**DOCUMENT 00 90 00**  
**ADDENDUM**

**ADDENDUM No.:** 1

**RE:** WESTERN TECHNICAL COLLEGE  
COLEMAN CENTER 2024 RENOVATION  
368 6TH ST NORTH  
LA CROSSE, WISCONSIN 54601  
PROJECT NO. 23072

E101

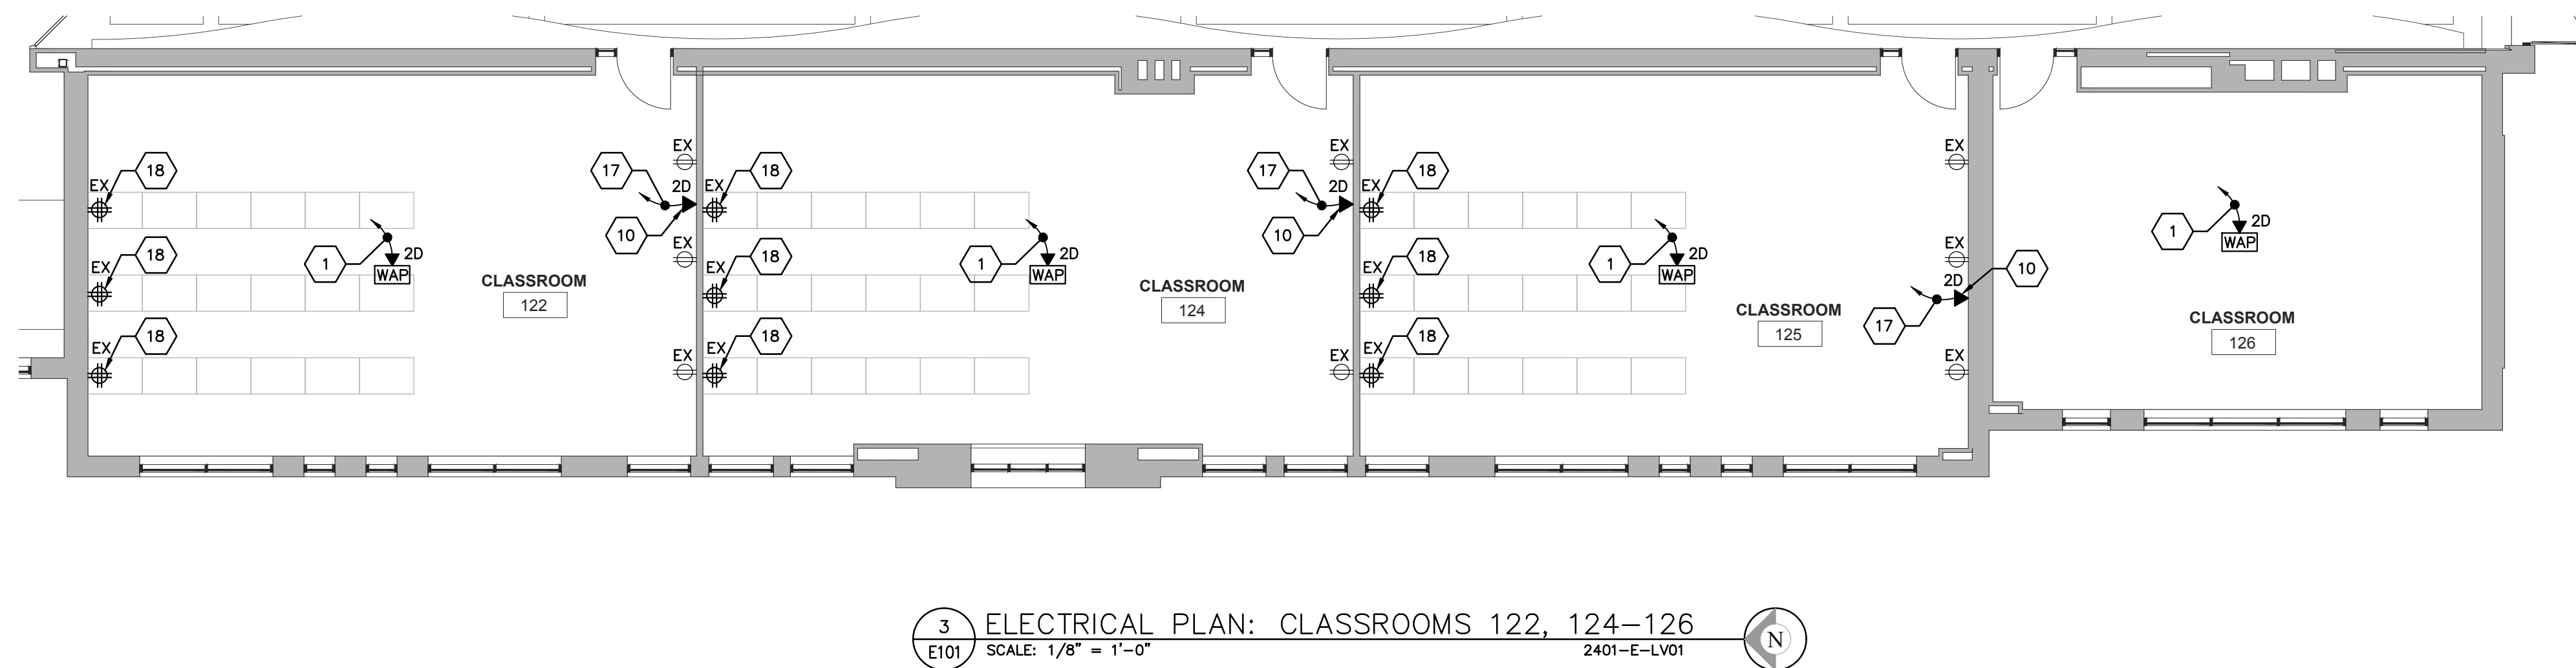
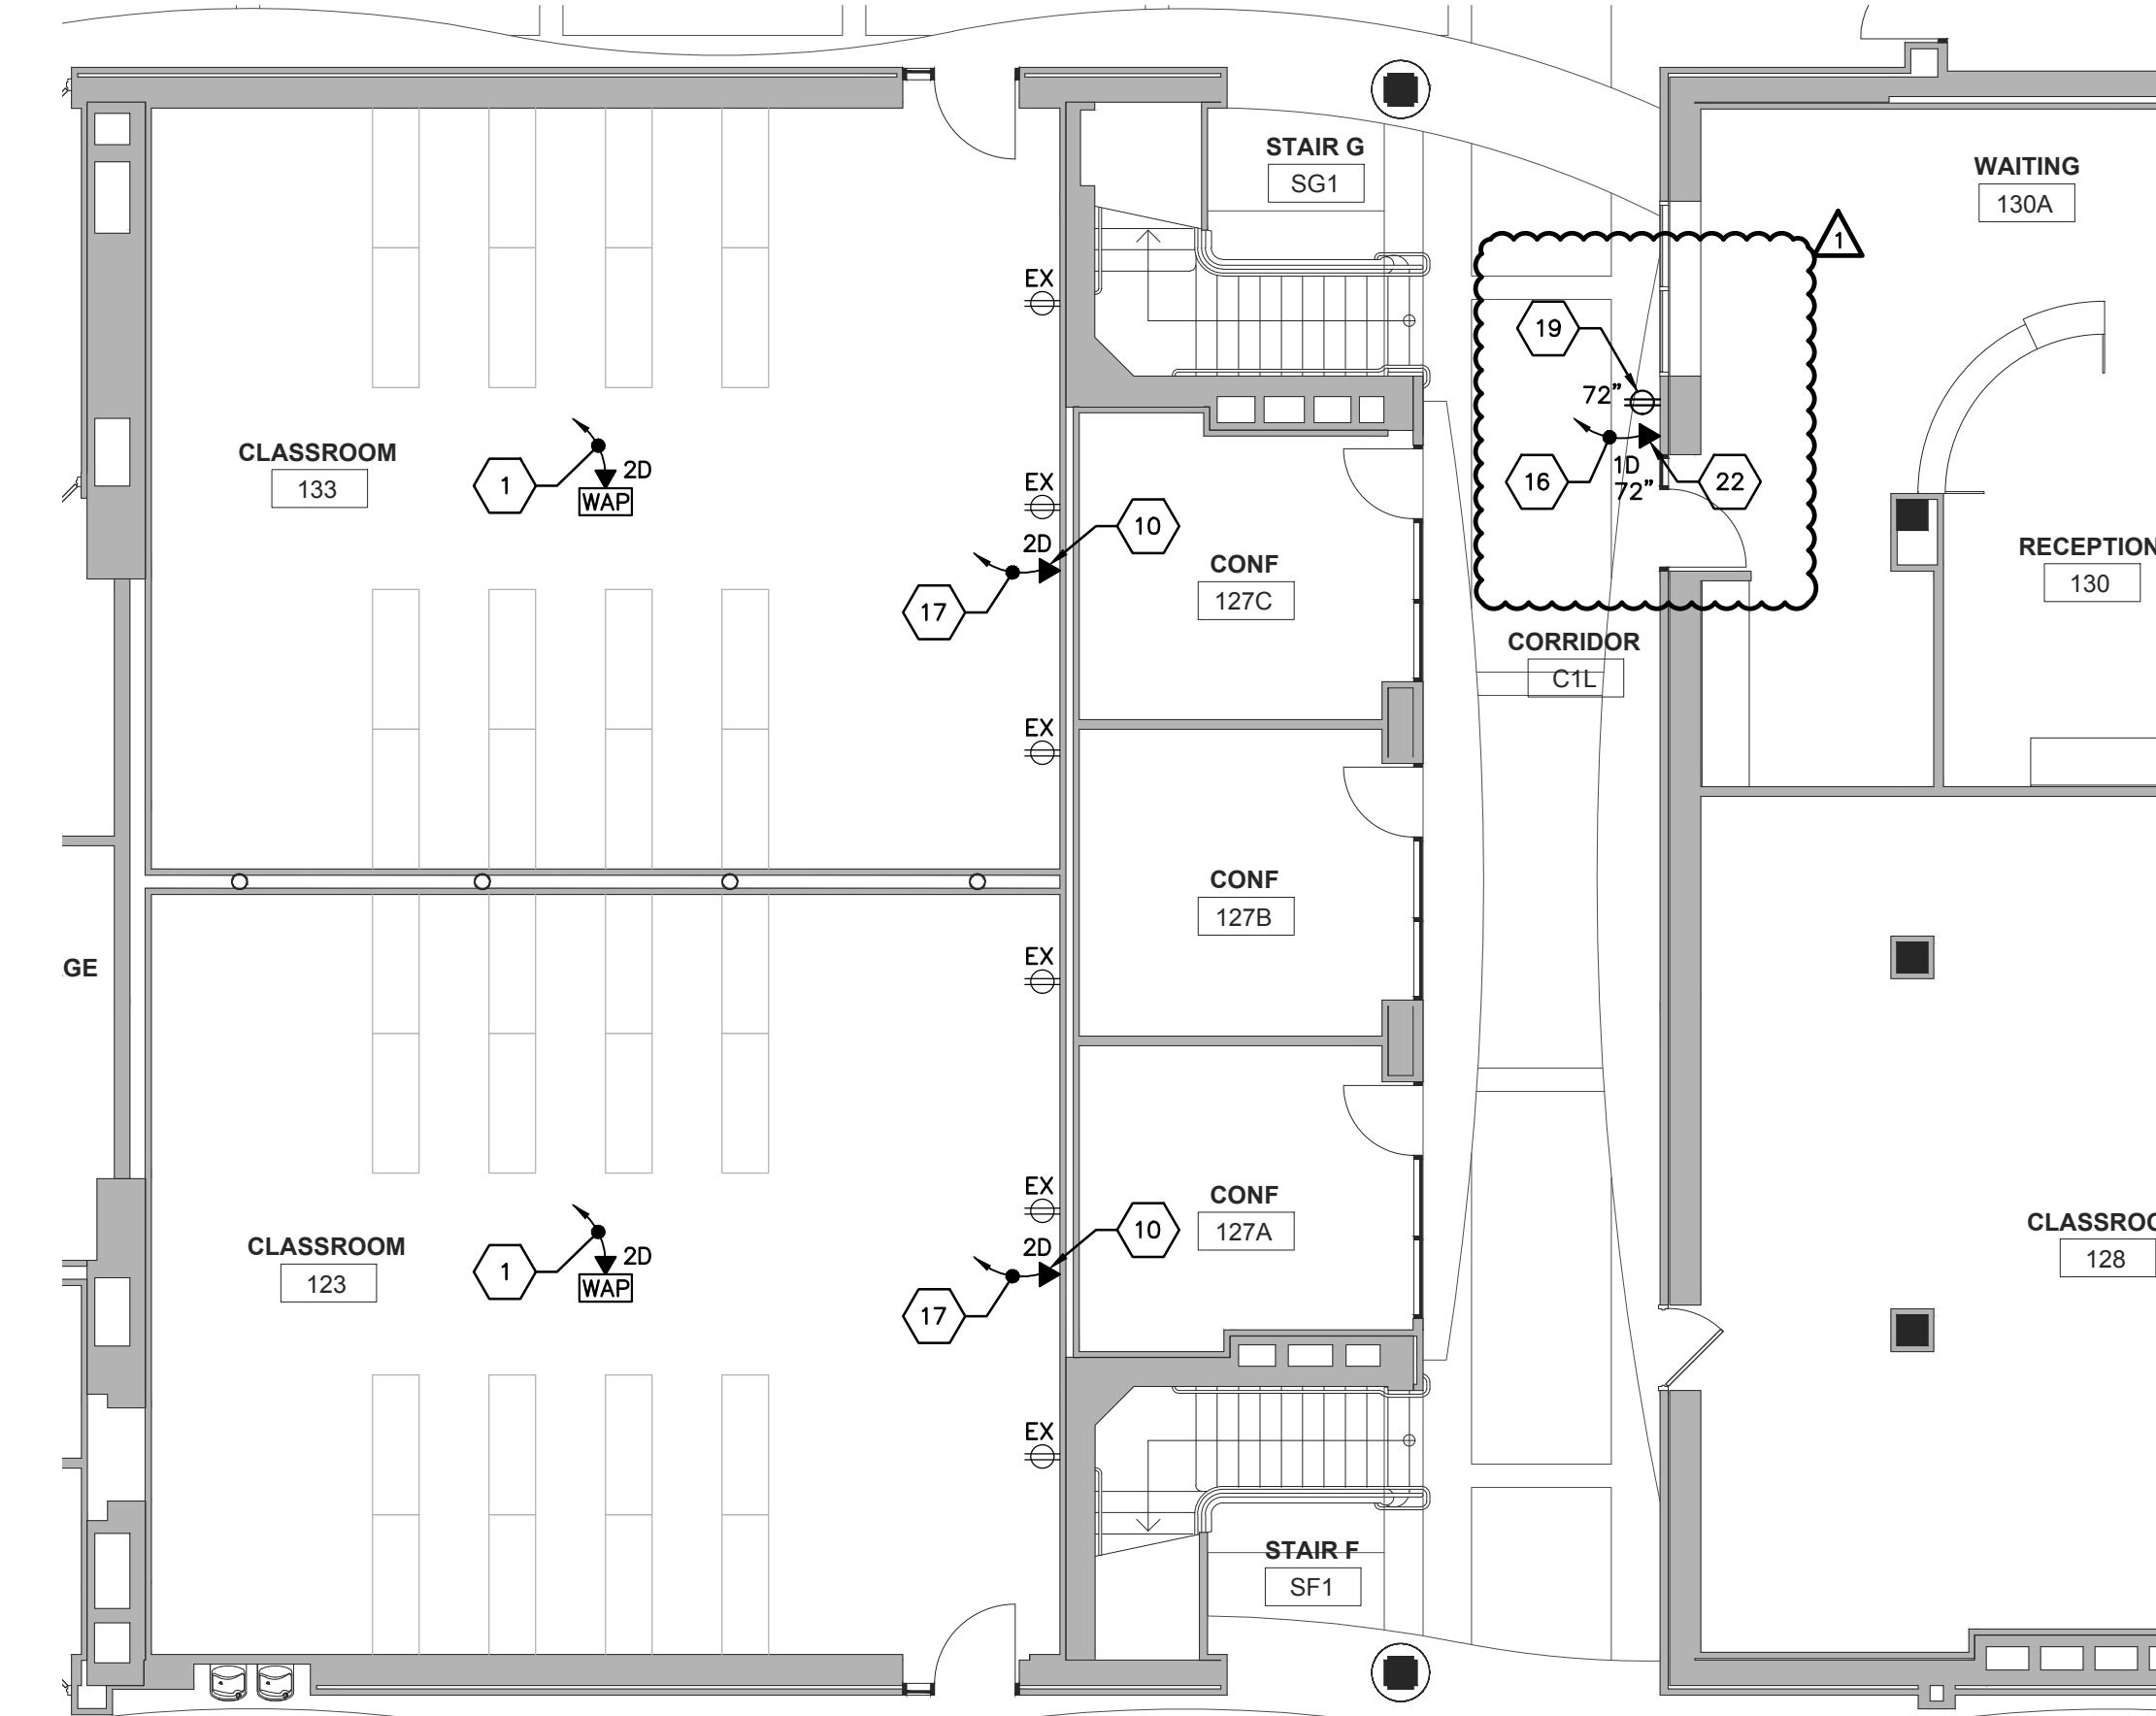
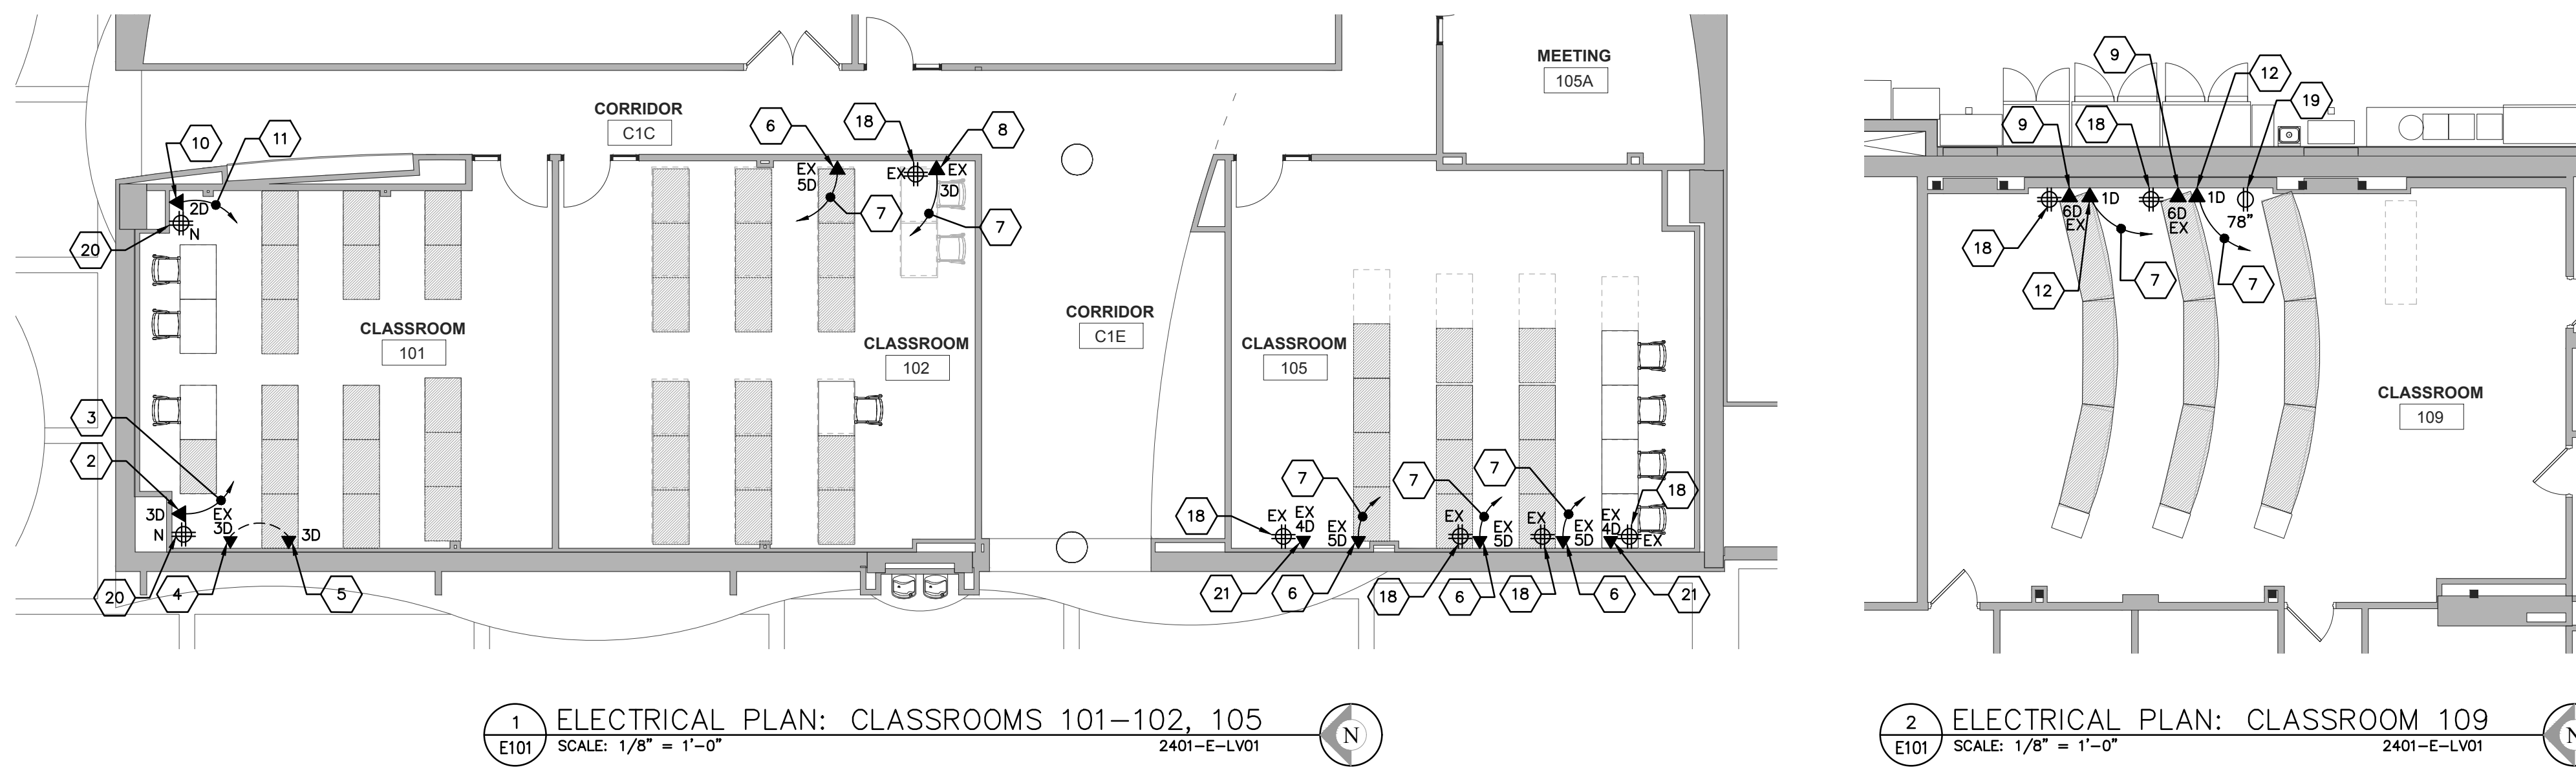
5. Sheet E101 CLASSROOMS ELECTRICAL PLANS 30"x42"
  - a. See the revised sheet included in this addendum. Disregard the previous version.
  - b. 4/E101: See clouded change for (1) added data jack for wall-mounted information monitor. See clouded change for (1) added duplex receptacle for wall-mounted monitor.

- c. Added Electrical Remodel Plan Notes Item #22.

- EXISTING 4-PORT DATA JACK TO REMAIN AS IS.
  - PROVIDE ONE NEW 1-PORT DATA JACK AT THIS LOCATION FOR INFORMATION MONITOR. IT WILL BE REQUIRED TO 'FISH' CAT6 CABLE AND INSTALL CUT-IN JUNCTION BOX IN EXISTING WALL. LOCATE ADJACENT TO NEW DUPLEX RECEPTACLE. FIELD VERIFY SCOPE OF WORK PRIOR TO SUBMITTING BID.
